HumeLink

Amendment Report

FIGURE 3-4a: Changes to construction compounds

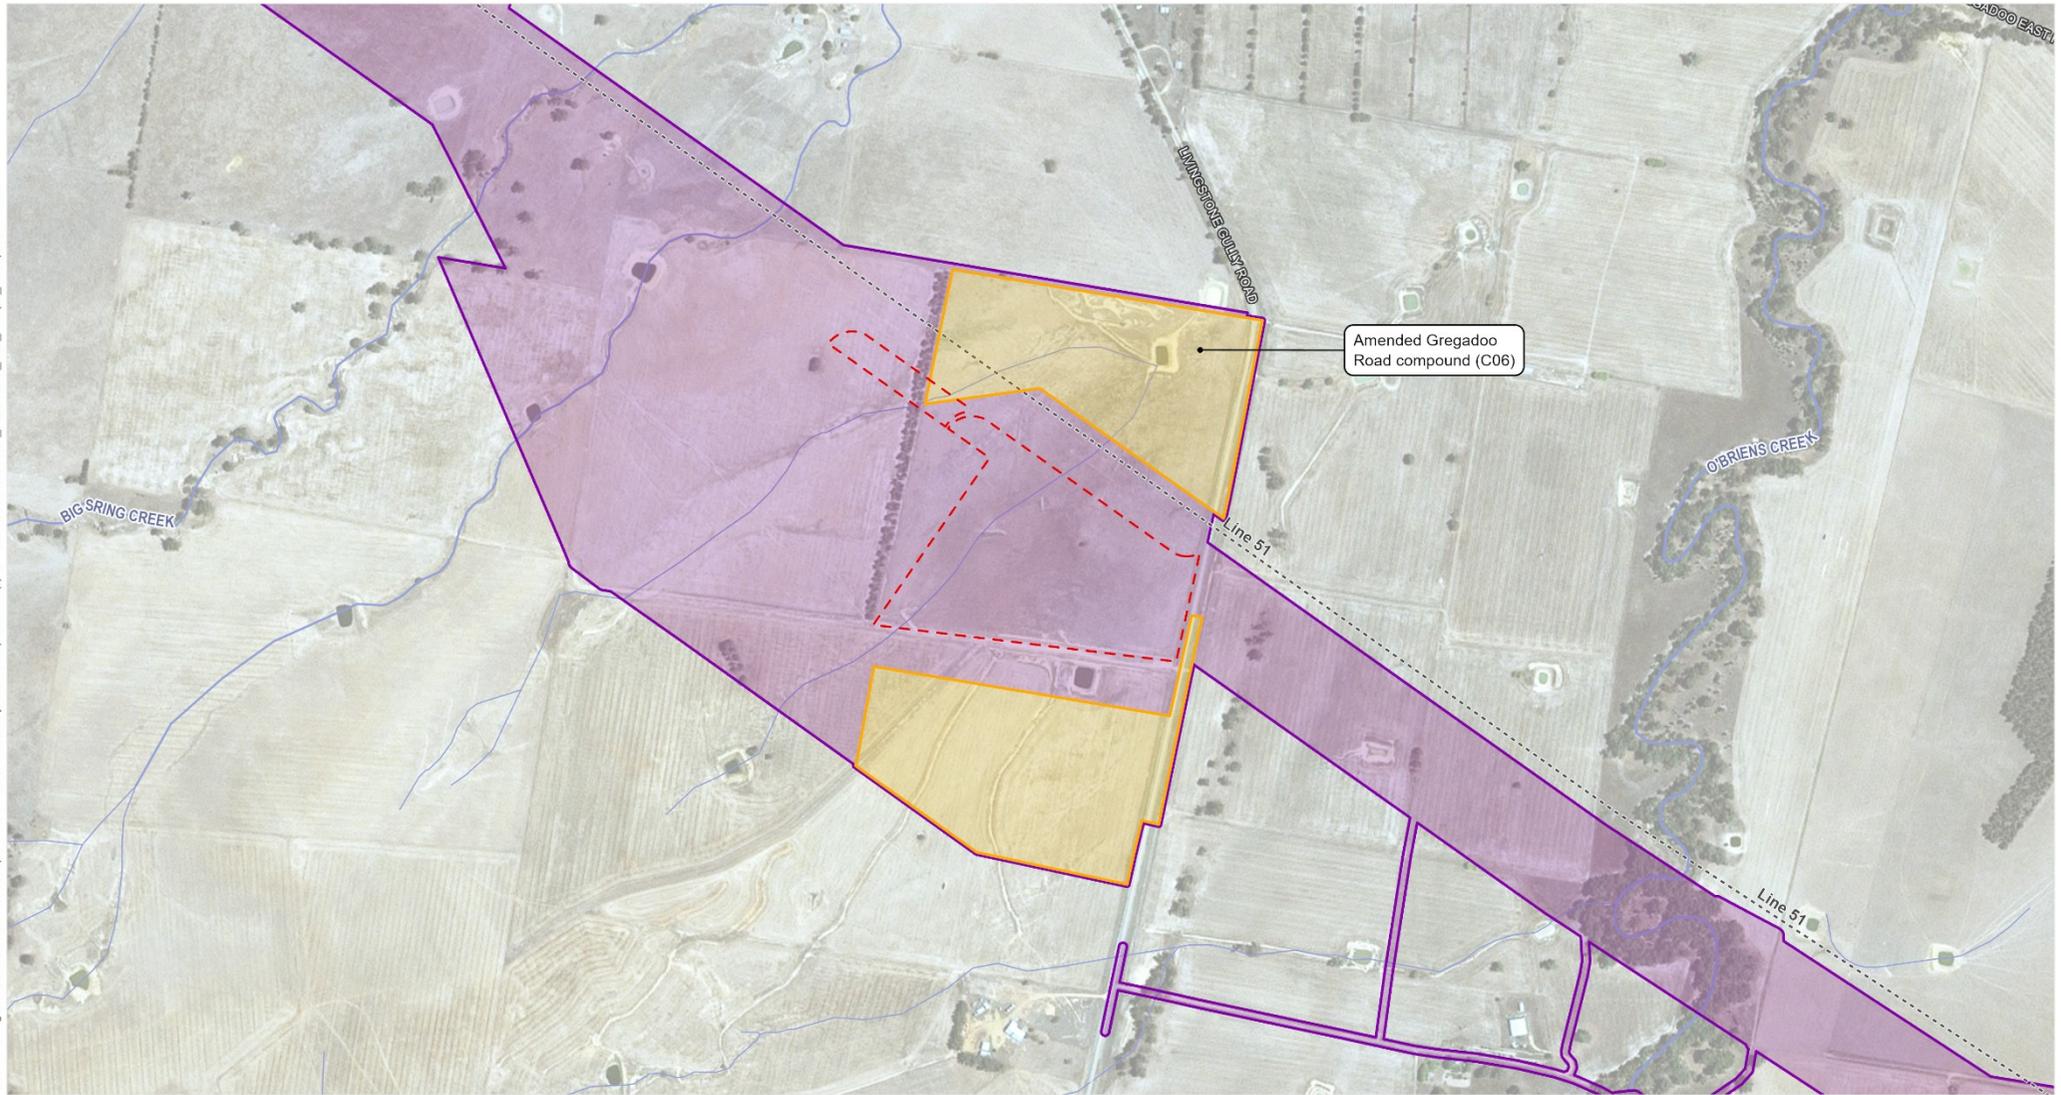
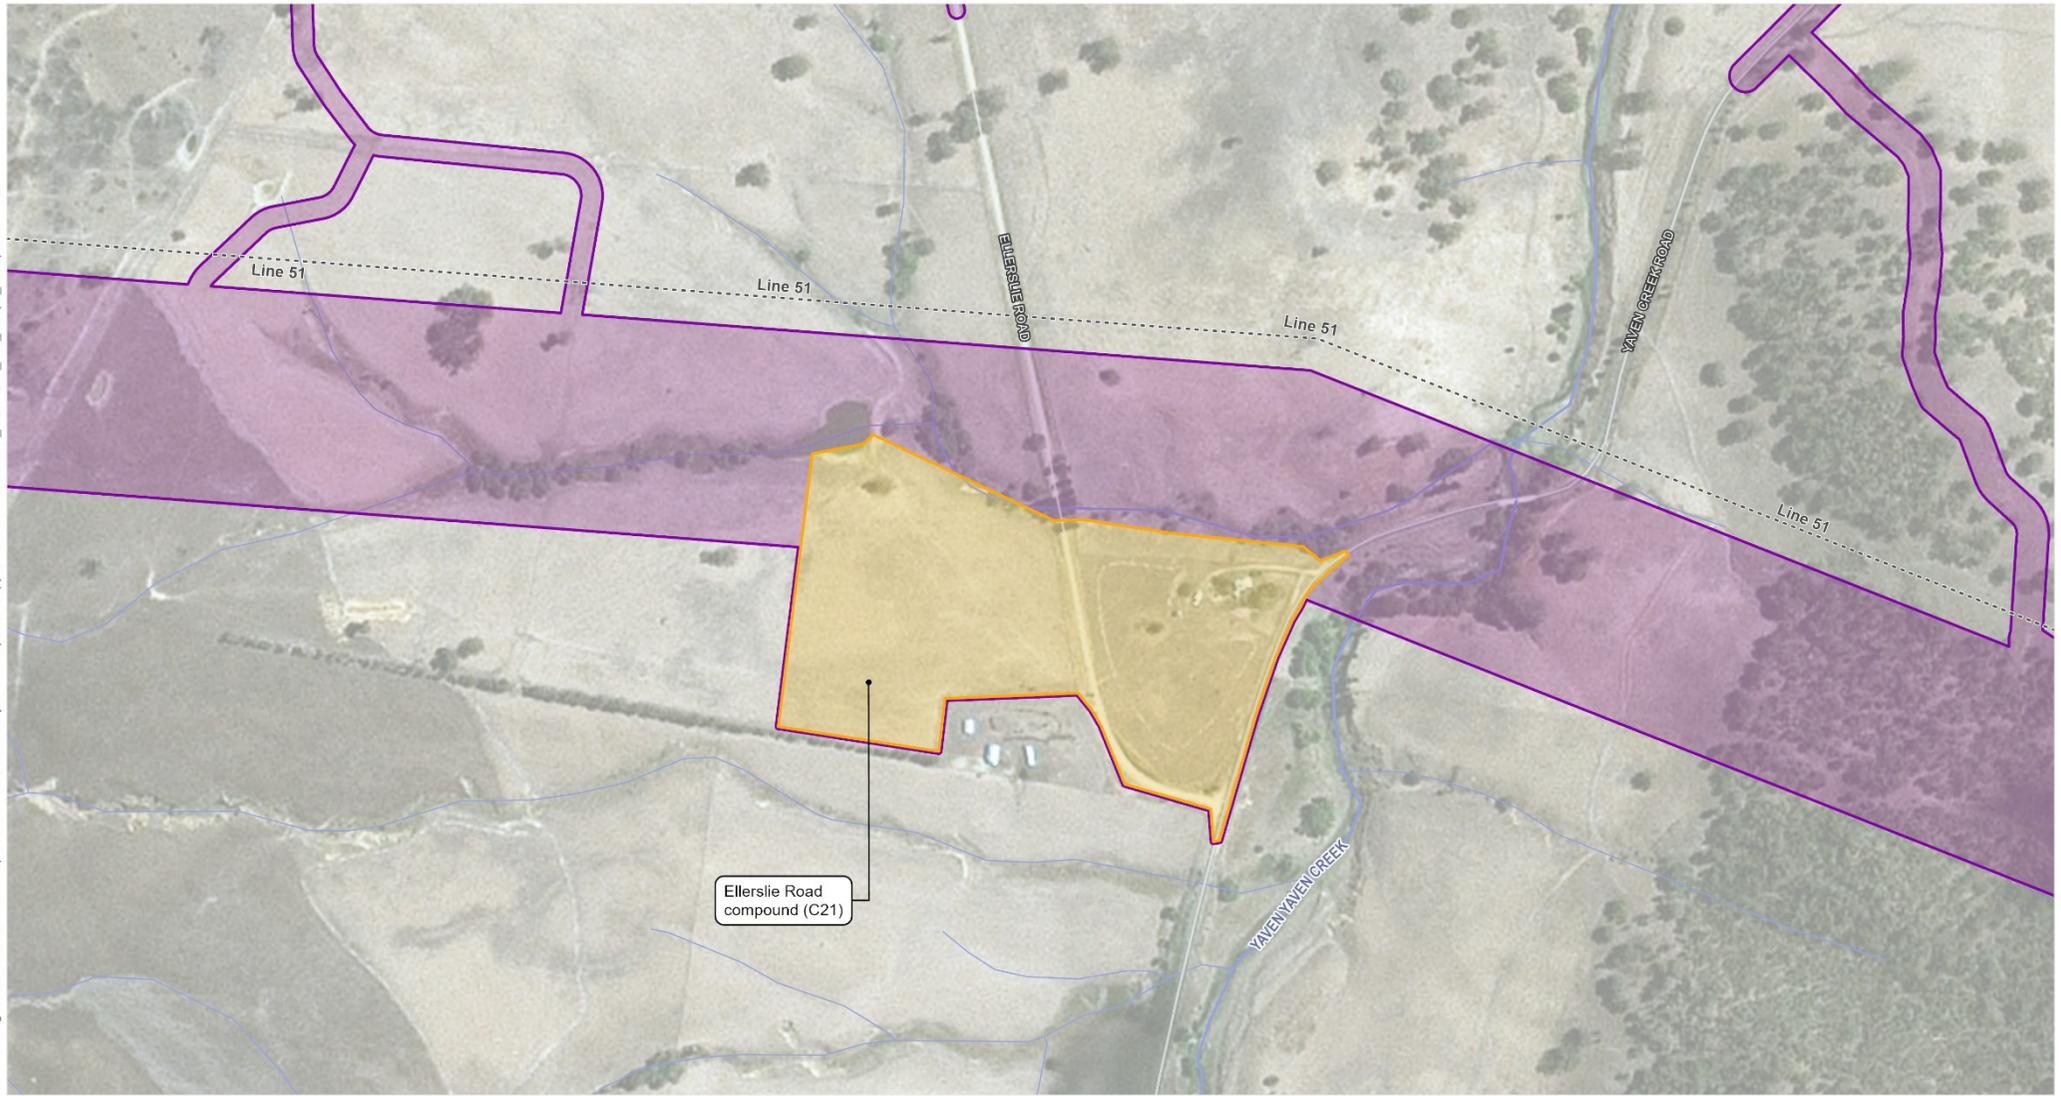
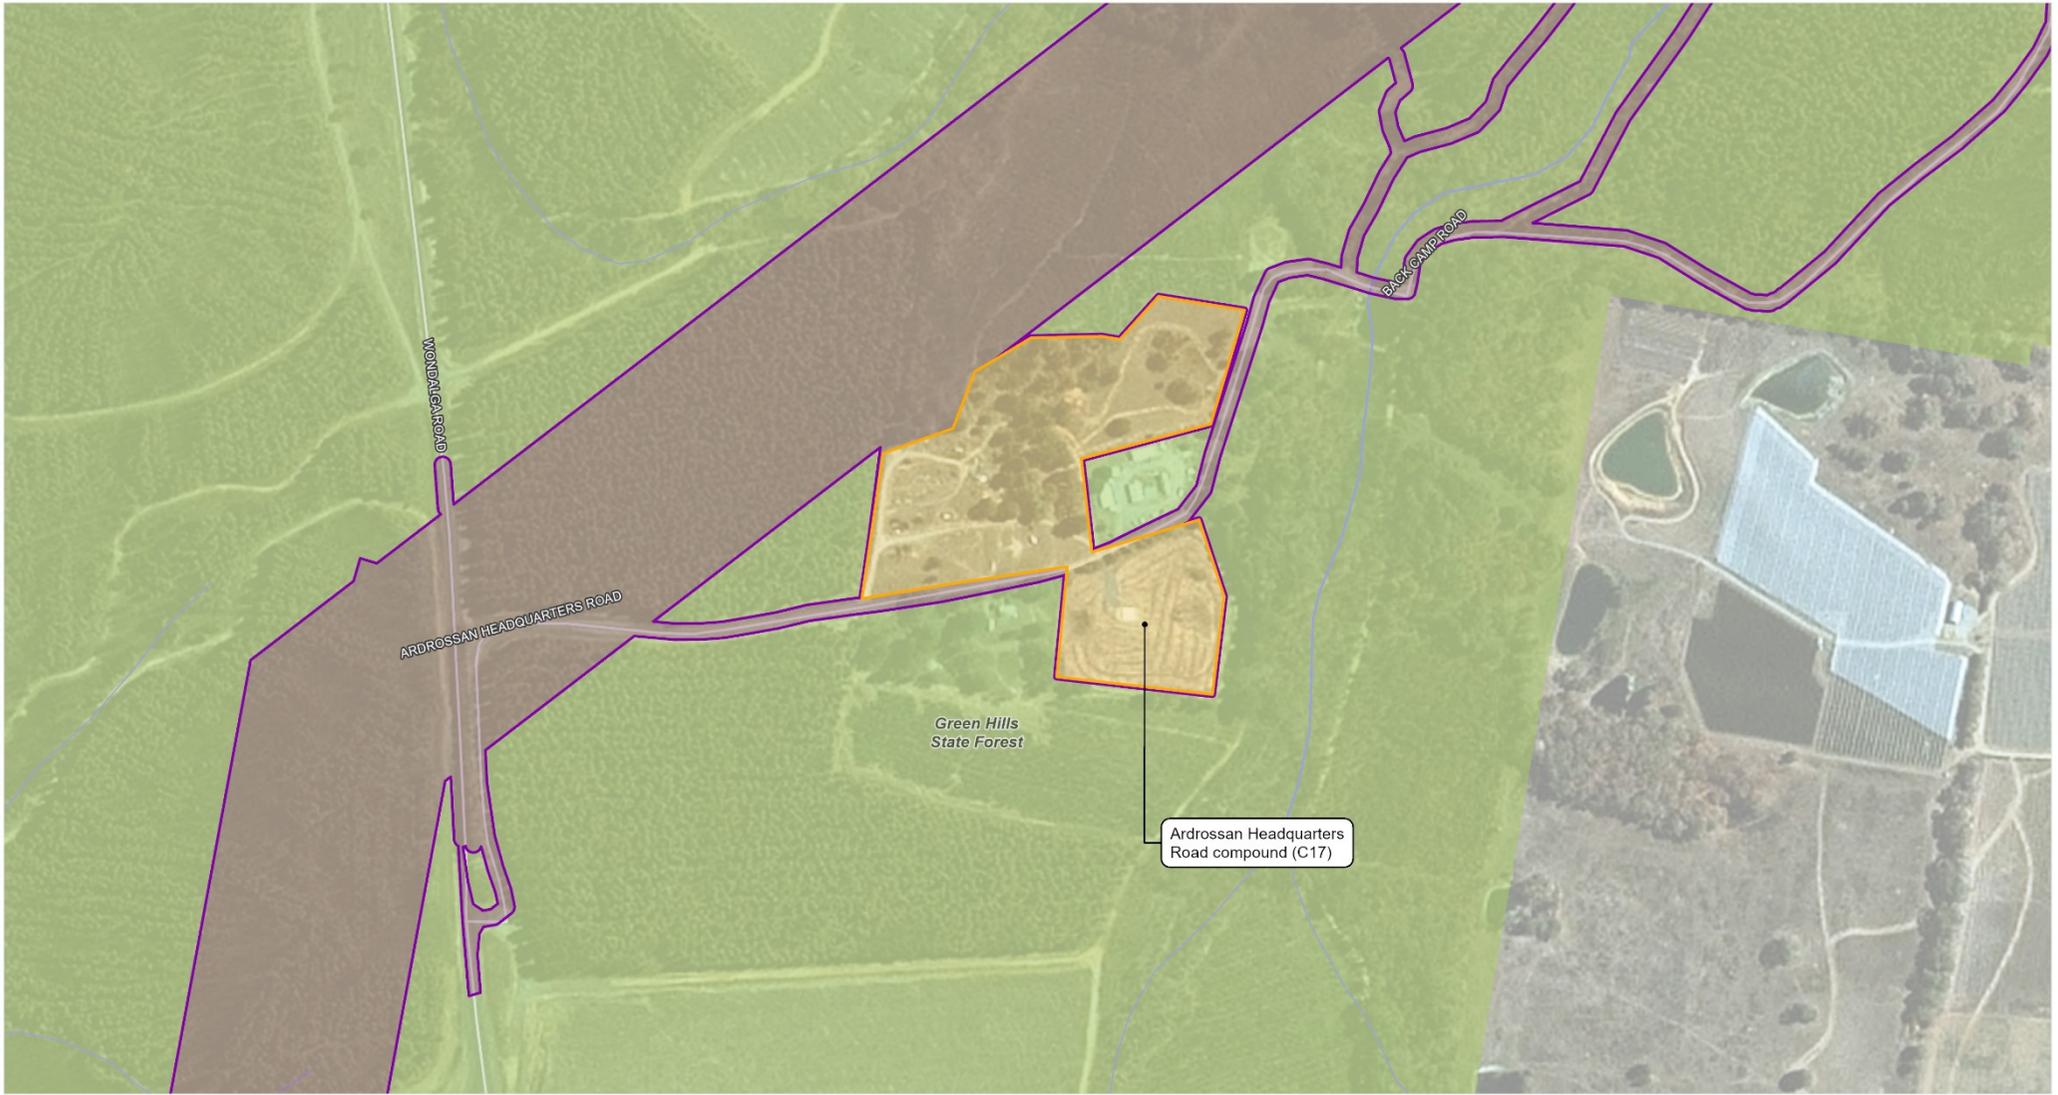
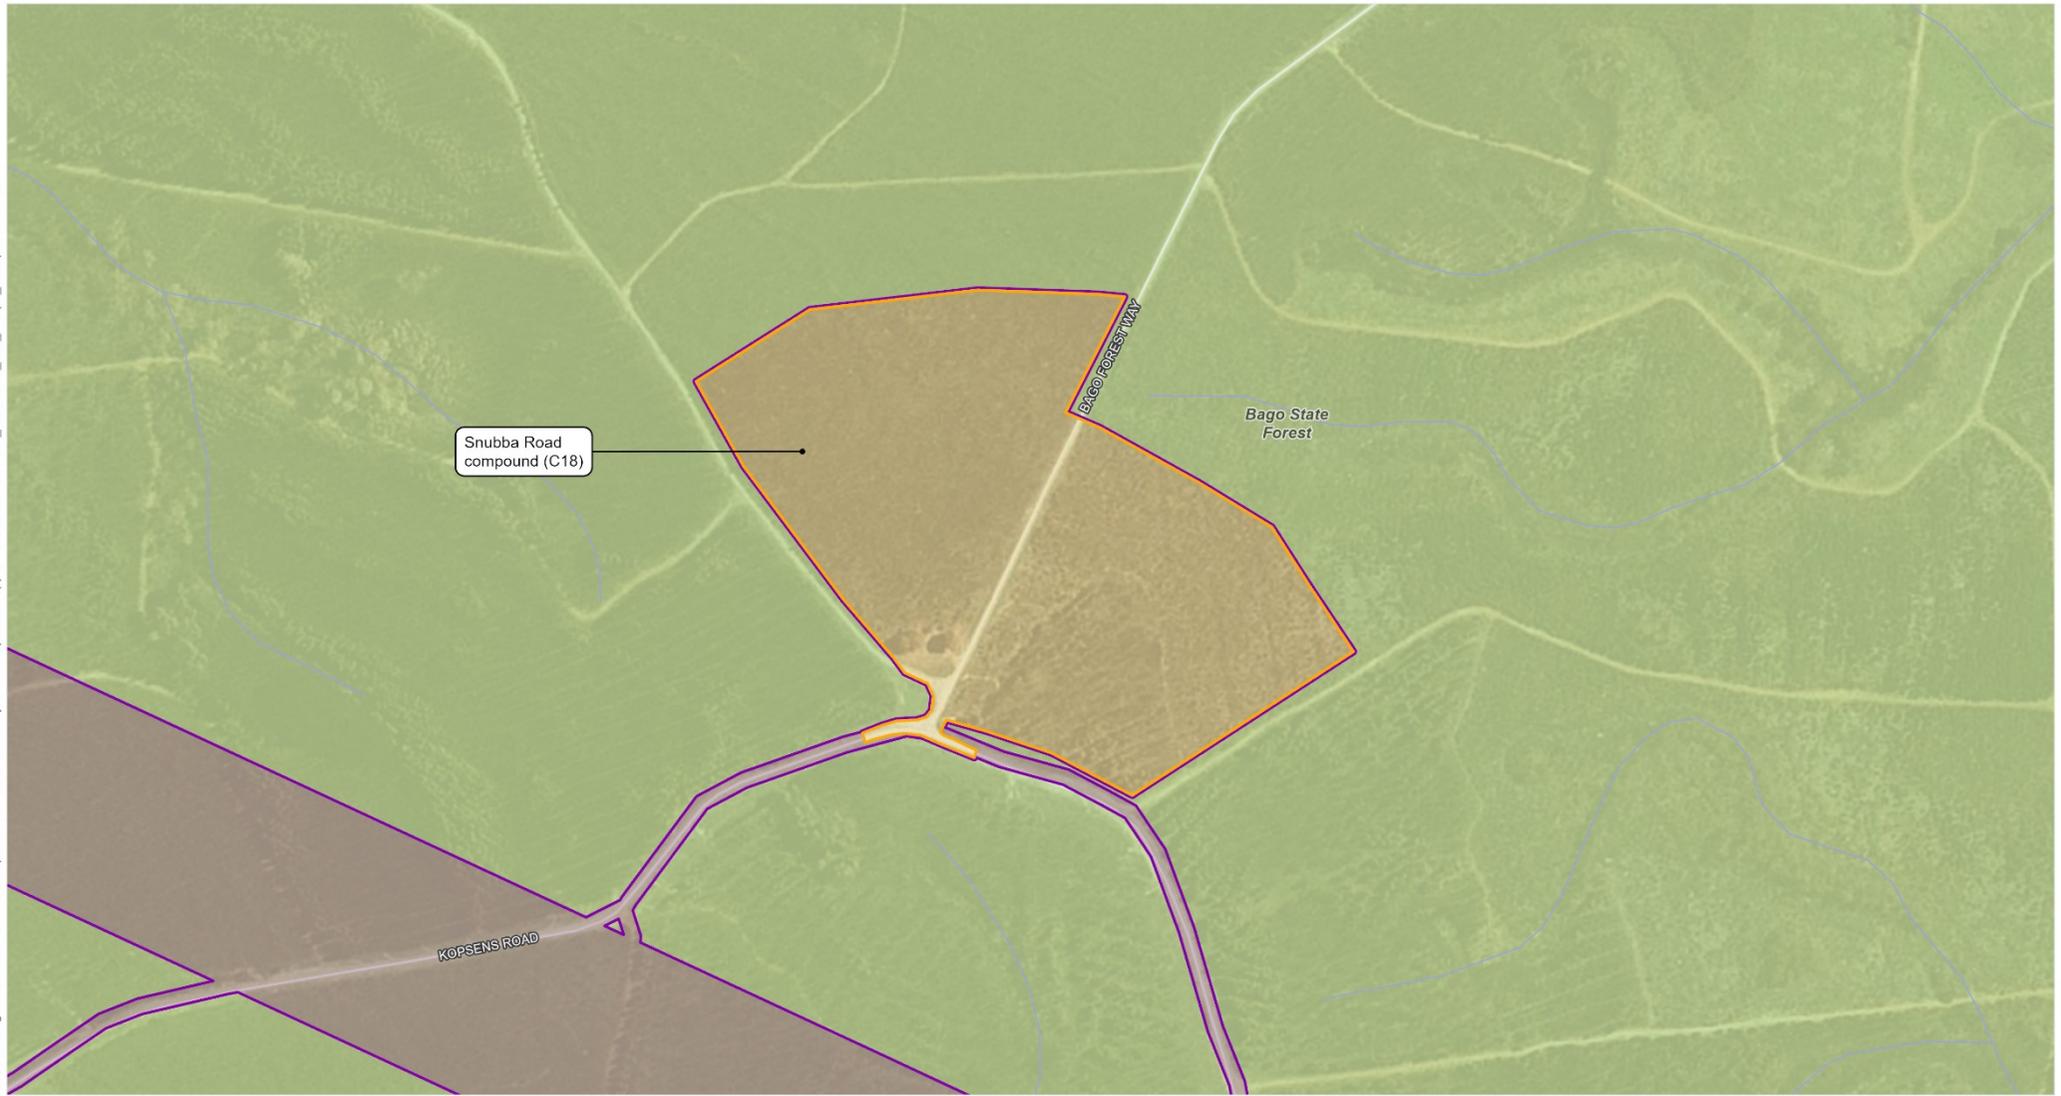
Table 3-4 provides a consolidated list and description of the standalone construction compounds. Further detail is provided in Appendix A (Updated project description). Figure 3-4 shows the locations of the changed standalone construction compounds.
